**RC245009 Proposed Cornerstone Church, Rolleston
Response to Council Request for Further Information**

Further to our recent e-mails, we understand that further to our previous review of the proposed church site layout, Selwyn District Council has issued a s 92 request, requesting further information on various issues (**RFI**). This letter responds to that request. For ease of reading we have adopted the same numbering as used in the RFI, and briefly summarised the matter raised before responding.

Figure 1: Additional Parking Area (Extract from Whimbrel Drawing)

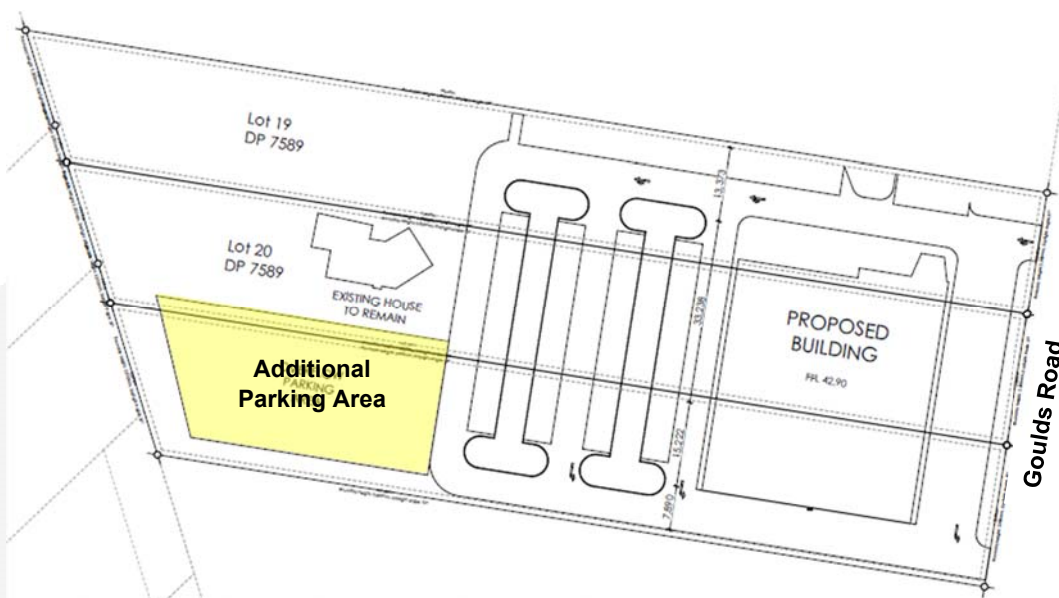
RFI Matter 5(a): Car Parking: The extent to which on-street car parking is anticipated and how this may affect the safety and capacity of the transport network.

The church has also identified an additional area towards the immediate west of the proposed car park. Although no detailed drawings have been produced of a parking layout, the area is regular and therefore conducive to an efficient layout.

This area is 1,200sqm in size. The Partially Operative Selwyn District Plan indicates that two parking spaces would be 2.5m wide and 5.4m deep, separated by an aisle of 5.8m, which then equates to 21sqm per parking space. It is highly unlikely that this degree of efficiency would be achieved, and we note that the existing car park achieves in the order of 30sqm per parking space. Applying the latter indicates that the additional car parking would provide a minimum of 40 car parking spaces.

Including these additional 40 spaces results in a total on-site parking provision of 154 spaces. As noted above, the maximum parking demand associated with the maximum occupancy of the building will be 153 spaces. Consequently the site remains self-sufficient for parking.

For clarity, we highlight that it is not expected that the additional car parking area will be formed immediately but rather, it will be formed as and when parking demands increase in future.
